# Work Order ID 88965

Item Name: Crosstube Turning Detail

**D206-667-241**  
**ASSEMBLY DETAIL**  
(VIEW LOOKING FWD)

DRAWING NO. D206-667-241	TITLE CROSSTUBE ASS'Y (206B HIGH AFT)	REV. C	<b>DART AEROSPACE LTD ENGINEERING ORDER</b>		D.E.O. NO. D206-667-241-C-1	SHEET NO. SHEET 1 OF 1	SCALE NTS
DRAWN <i>q</i>	CHECKED <i>AS</i>	MFG. APPR. <i>M</i>	APPROVED <i>MD</i>		DE APPR. <i>MD</i>		
DATE 11.07.15	DATE 11.08.22	DATE 11.08.22	DATE 11/08/22		DATE 11.08.22

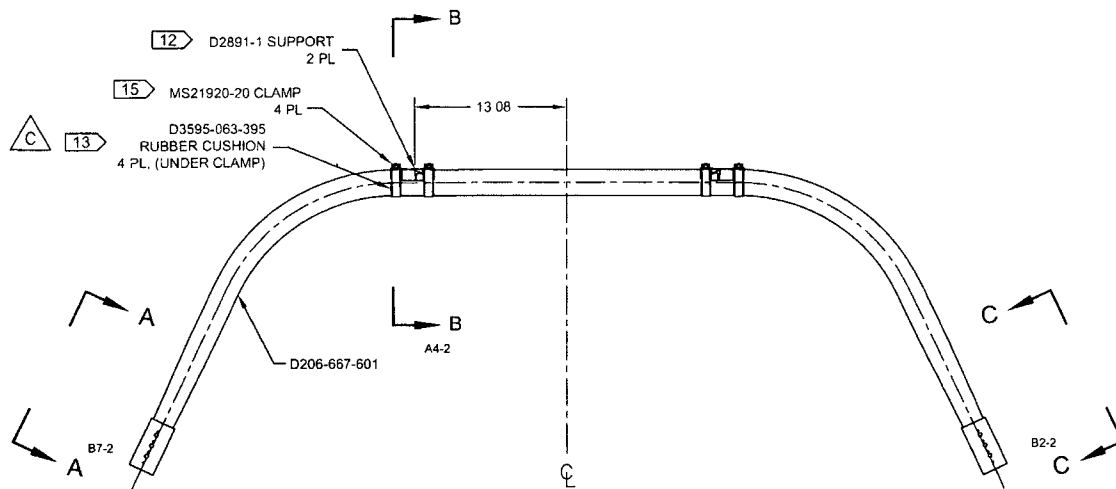
NOTE 12 & 15, SHEET 1 IS AMENDED AS FOLLOWS:

**WAS:**

- 12) INSTALL D2891-1 SUPPORT USING 0.03" TO 0.06" THICK LAYER OF MAGNOBOND 6398 PER QSI 015. LET CURE FOR 12 HOURS AFTER INSTALLATION AND PRIOR TO PACKAGING.
- 15) TORQUE CLAMPS 80 TO 100 IN-LB. ENSURE AT LEAST 1.5 THREADS SHOWING IN SAFETY AND THAT NUT HAS NOT BOTTOMED-OUT AFTER TORQUING.

**IS:**

- 12) TO INSTALL D2891-1 SUPPORT: ABRASE MATING SURFACE OF SUPPORT AND CROSSTUBE WITH 180-GRIT SANDPAPER AND REMOVE RESIDUE WITH MEK (OR EQUIVALENT). APPLY A 0.04" TO 0.07" THICK LAYER OF PROSEAL 890 CLASS B-2 (OR AMS-S-8802 CLASS B-2) SEALANT TO MATING SURFACE OF SUPPORT.
- 15) TORQUE CLAMPS 80 TO 100 IN-LB. ENSURE AT LEAST 1.5 THREADS SHOWING IN SAFETY AND THAT NUT HAS NOT BOTTOMED-OUT AFTER TORQUING. **PRIOR TO PACKAGING, RE-CHECK TORQUE ON CLAMPS AFTER PROSEAL 890 SEALANT HAS CURED FOR 72 HOURS.**
